The Appropriateness of the drainage strategy which underpins the Arden Structure Plan

49-51 Henderson Street & 62-70 Gracie Street, North Melbourne

Professor Peter Coombes

February 2022

Figure 7: Maximum rainfall rates within design storm events with two hour durations for ARR1987 and ARR2019

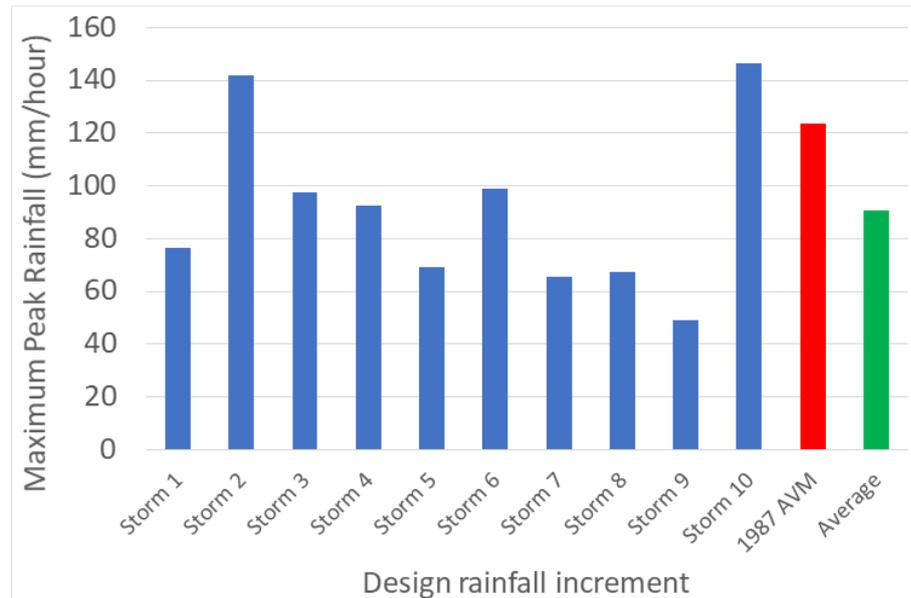
78. Figure 7 demonstrates that the ensemble of ten design storm patterns from ARR2019 involve a wide range of maximum rainfall rates for a 5 minute increment versus of single maximum rate provided by the ARR1987 design storm.²⁶ Importantly, the ARR2019 methods involves choosing the storm pattern that produces to average response for the critical storm duration. This implies that average maximum rainfall rate of 90 mm/hour applies and this is considerably less that maximum rainfall rate of 123.7 mm/hour from ARR1987.

79. A further insight from Figure 7 is that storm pattern 4 might provide the critical temporal pattern for this location. This discussion highlights the vitally important consideration of the need for best practice methods to establish critical design storm durations and temporal patterns to understand flood risks in urban catchments with volume sensitive characteristics. This is done by choosing the critical duration and temporal patterns of design storms based on changes in flood elevations with verification by observed flood depths – not by selection of maximum peak rainfall and runoff.²⁷

Figure 8: Overview of the critical processes involved in the historical hydraulic modelling of the Arden Macaulay Precinct

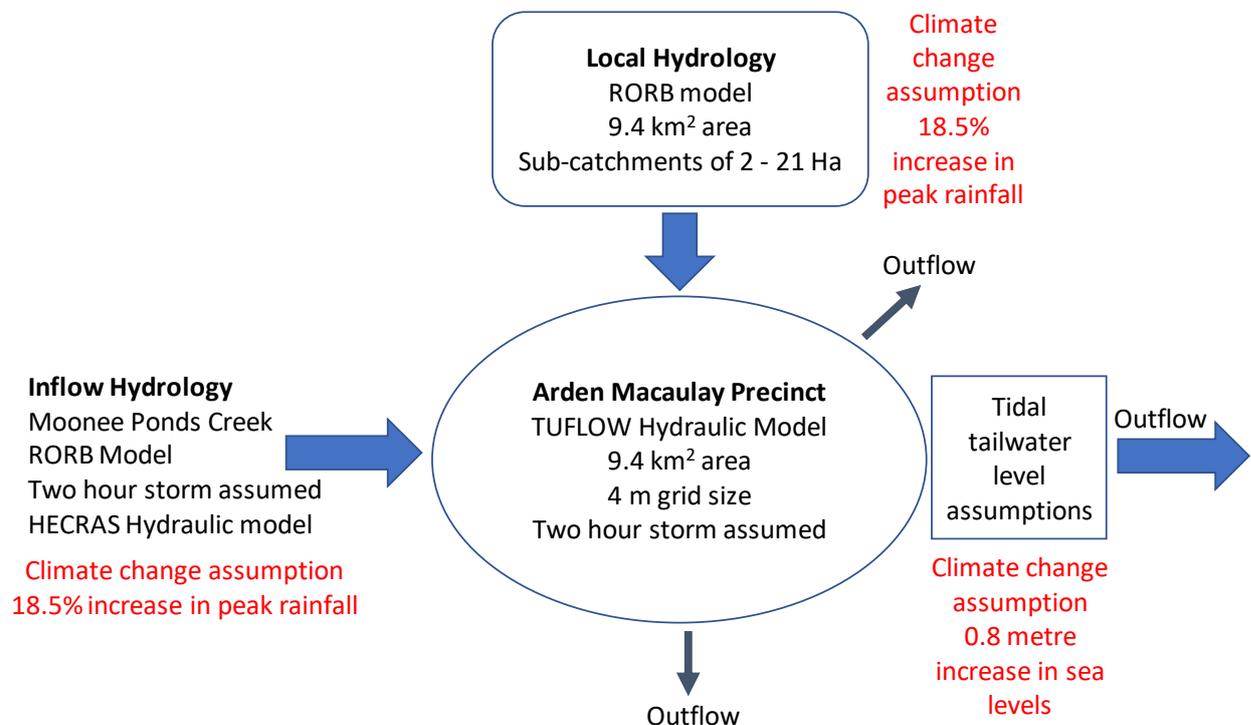
97. Figure 8 highlights that the hydraulic modelling to determine flood levels within the precinct is critically dependent on the inflow hydrology from Moonee Ponds Creek, local hydrology and tidal tailwater assumptions. These external assumptions drive the flood heights and durations within the precinct.

Figure 9: Overview of the catchment within the hydraulic models (after Engeny, 2020)

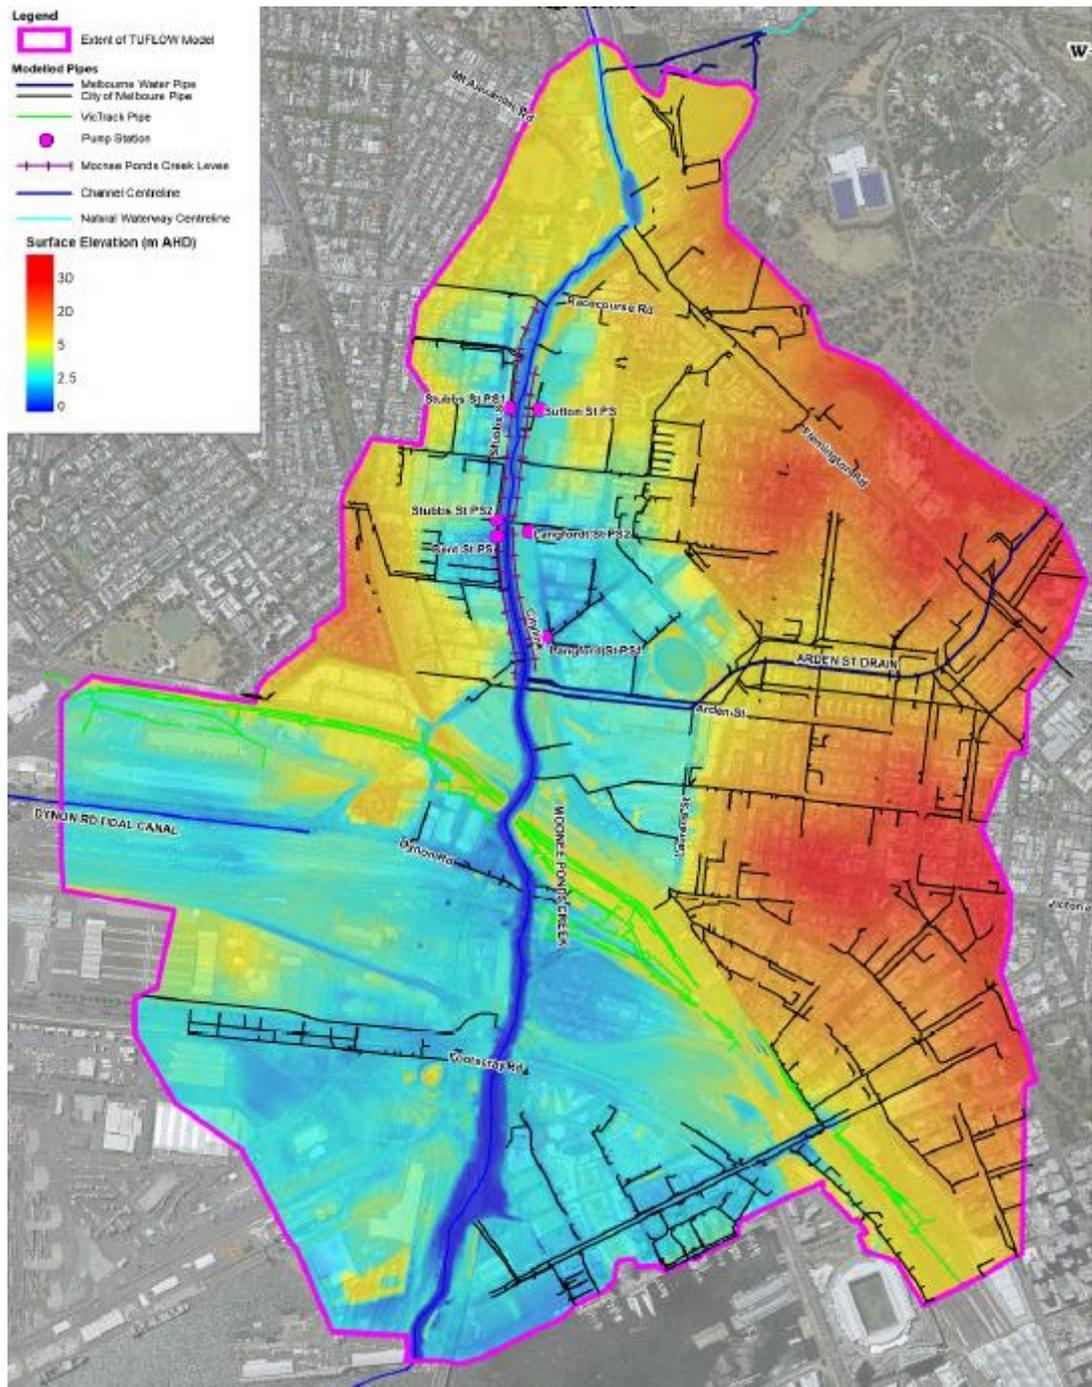
101. Figure 9 also shows that the local topography and infrastructure were important considerations in the hydraulic modelling. The local hydrology was modelled using the RORB software based on large sub-catchments ranging from 2 ha to 21 ha that might not be suitable for flood analysis of an inner city area with flat grades.

102. This can lead to flow pathways and local accumulation of stormwater volumes in the model that are different to reality.

109. The flood picture in Figure 9 shows the storage of stormwater in the low lying streets and highlights the importance of the pump at the intersection of Langford and Gracie streets, and any gravity connections (subject to tailwater conditions) for reducing the volume of stored stormwater in this area.

Figure 11: The portion of the upstream catchment, that should flow into the Arden Street Drain, directed to Macaulay and Gracie Streets in the local hydrology model

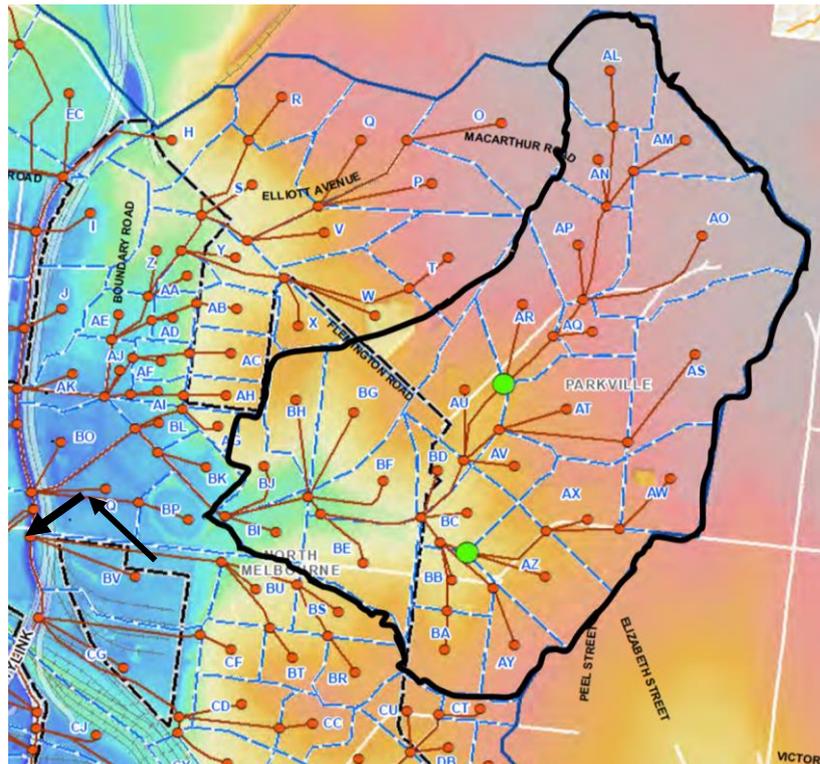
112. Figure 11 highlights that most of the Arden Street Drain catchment may have been directed down Macaulay and Gracie streets rather than the Arden Street Drain in the hydrology model – and therefore in the hydraulic model.

Figure 12: Verification of the hydraulic model to local flooding records from 6 March 2010.

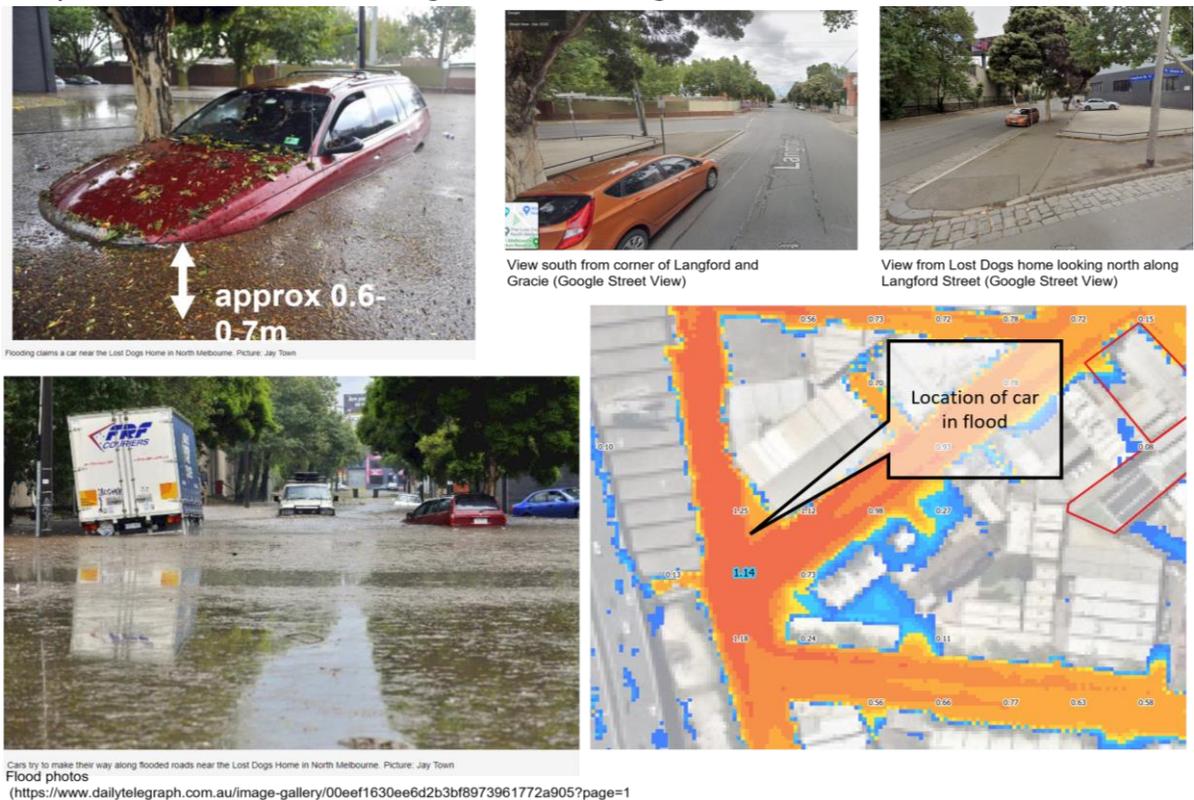
161. Figure 12 reveals that the hydraulic model predicted a flood depth of 1.14 m at the location of the car in the flood picture which is deeper than estimated observed flood depth of 0.6 – 0.7 m. This photograph of the flood depth at car might have been taken after the peak flood as indicated by the leaves on the bonnet of the car. The hydraulic model was capable of estimating the observed local flood depths at the sub-precinct and is suitable to examine the consequences of the insights of the investigation on the sub-precinct.

Figure 28. Comparison of modelling results with existing Planning Scheme (LSIO)

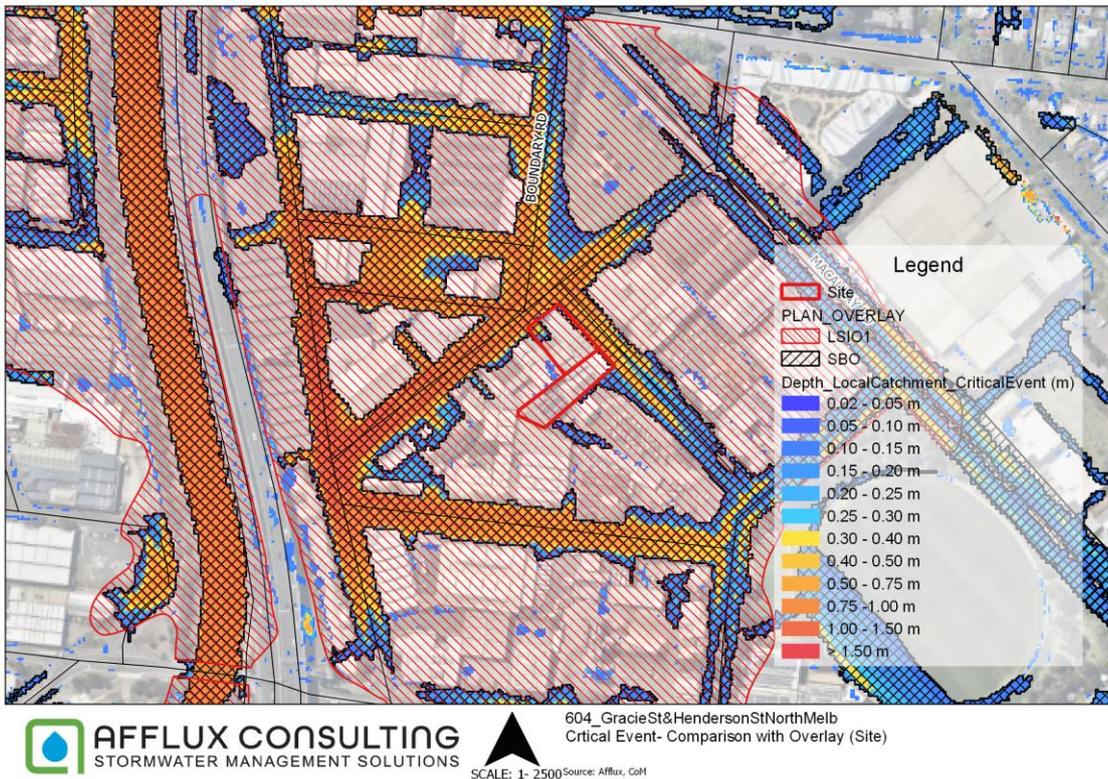
The difference between approaches is shown in Figure 28, while the overlay covers a wide area, the flooding itself is largely contained within road areas.

Figure 29. Observed Event, flood comparison along Langford Street

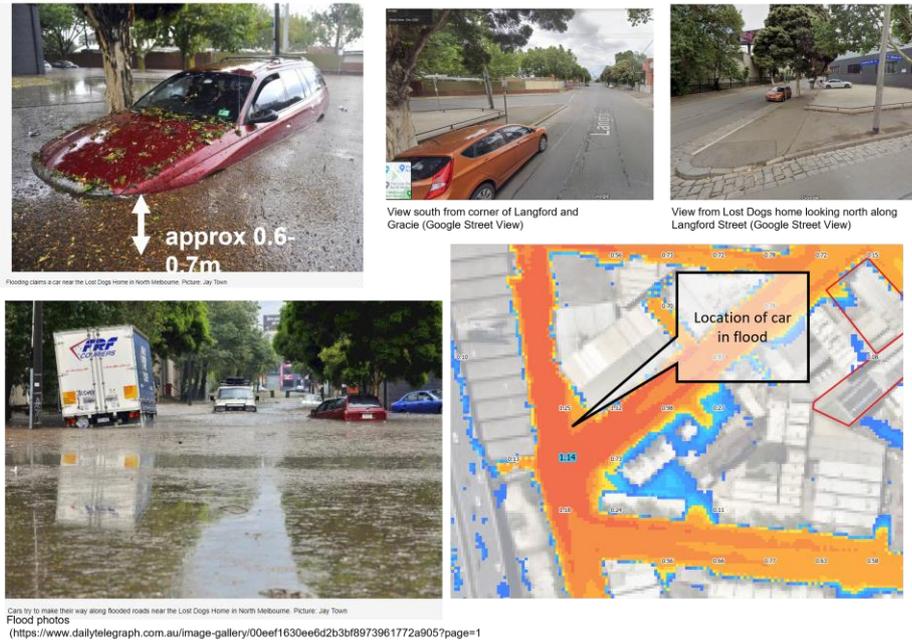
Figure 29 shows vehicles trapped in flood waters and are compared with the levels reported in the model run for the actual event. Modelling where the maroon car is located appears to align reasonably well with the modelled flood depth- water is deeper toward the front as the car dips down, and the flood waters become shallower toward the western edge of the road. Absolute depth reported (~1.2m) is slightly higher than the flood level shown on the impacted vehicle (which is estimated to be around 0.6- 0.7m in depth). Flooding extends some distance along the road at moderate depths as evidenced by the vehicle driving through the floodwaters.

- The simplified approach to introduce catchment runoff with no loss factors will lead to an overestimation of flood depth. Based on the nature of the study and available information, we have not sought to verify catchment surfaces and assign loss parameters.
- The location of pumps has not been verified through survey or accurate positioning. They have been assigned 'close' to where they are expected to be based on location description and assessment of terrain.
- Similarly, the operation of the pipe network has not been verified, and the extent of pipes is limited.

- It is not clear at what stage in the flood event the photo was taken. Presumably the reports were obtained after the flood event was notified, and delays in obtaining the pictures may have meant that the flood was abating.
